PROJECT: Tirey Hall Art Storage

ADDENDUM # 2

ADDENDUM NO. 02

TIREY HALL ART STORAGE
INDIANA STATE UNIVERSITY
TERRE HAUTE, IN 47809

DRAWING NO.: ADD2-FP1

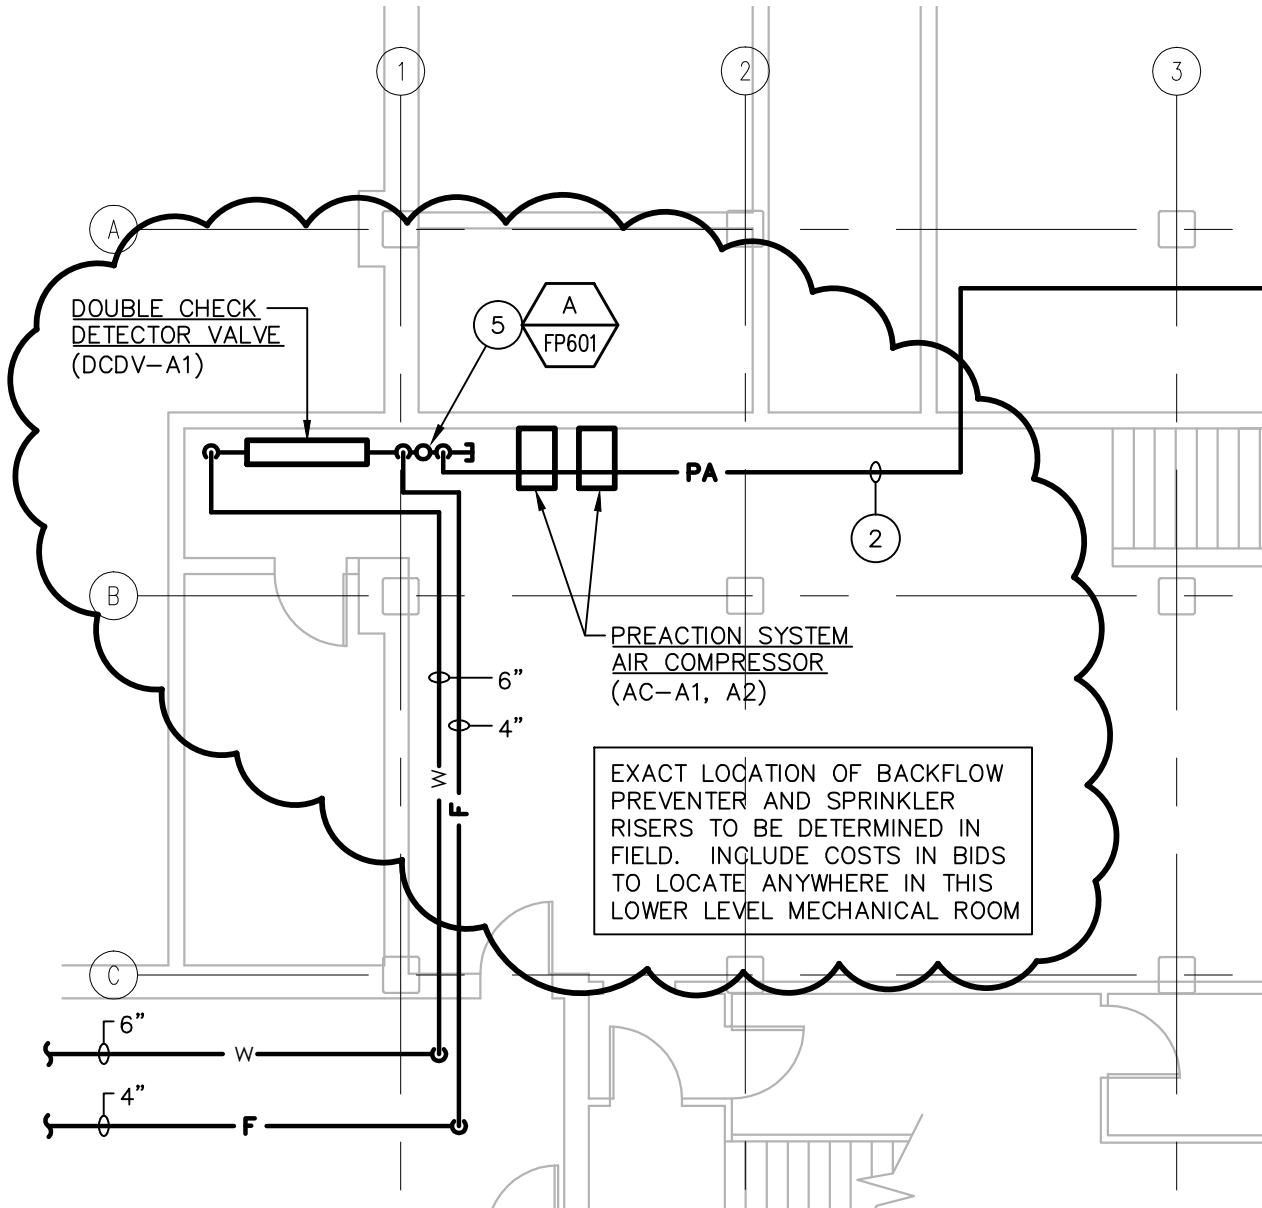
- vi. Coordinate all work with Simplex.
4. FP100 – Site Plan – Fire Protection
 - a. Refer to drawing ADD2-FP1 issued in this addendum for clarification of work in tunnel.

DRAWING NO.: ADD2-FP2

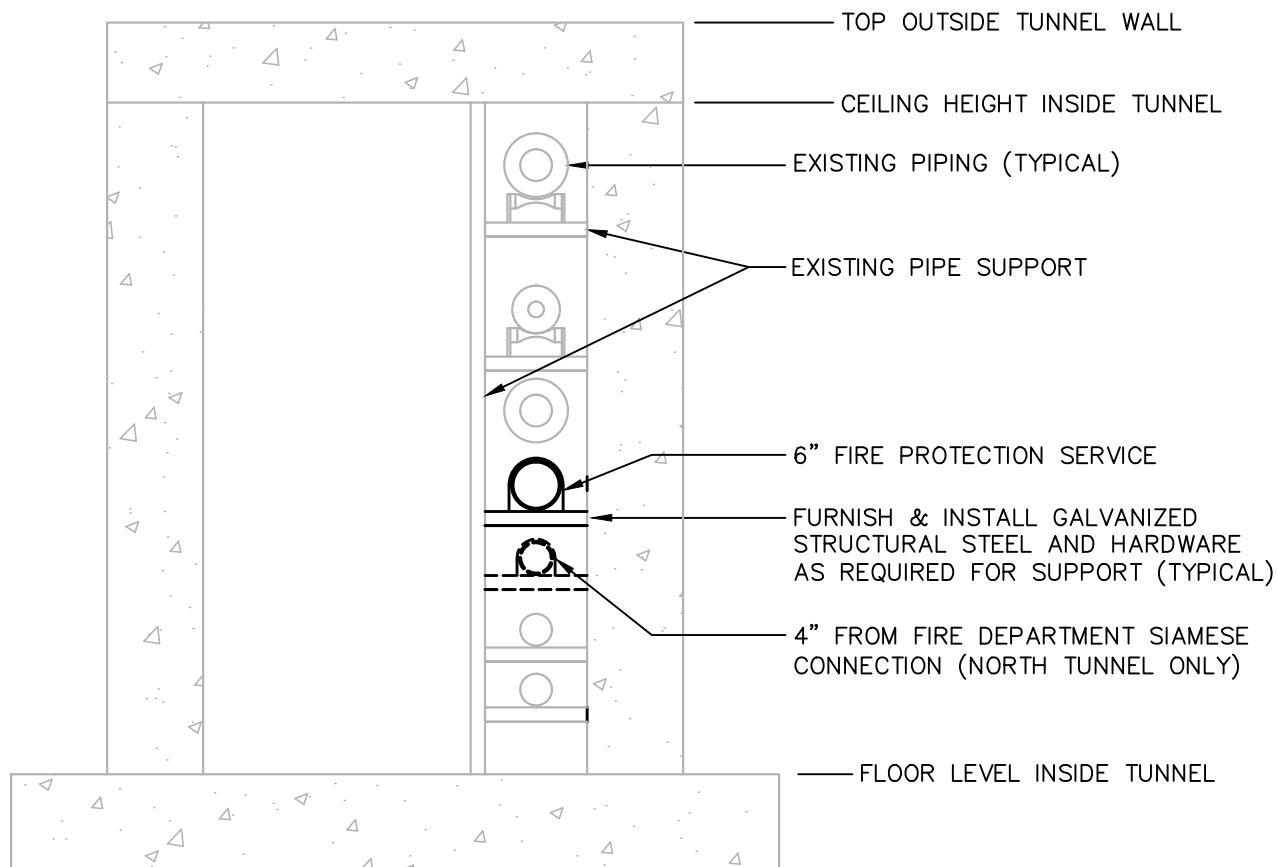
5. FP201 – Partial Floor Plans – Fire Protection
 - a. Refer to drawing ADD2-FP2 issued in this addendum for clarification regarding location of backflow preventer and preaction system.

- b. It is the intent that all fire protection piping will be installed exposed below the existing ceiling in the First Floor project area. The piping shall be supported from the existing structure above, not from the suspended ceiling. Contractor shall provide holes in the existing ceiling as required in order to install the necessary pipe supports. All such holes shall be patched with like material in order to maintain the existing ceiling barrier. Install piping as high as possible and coordinate with lighting layout.
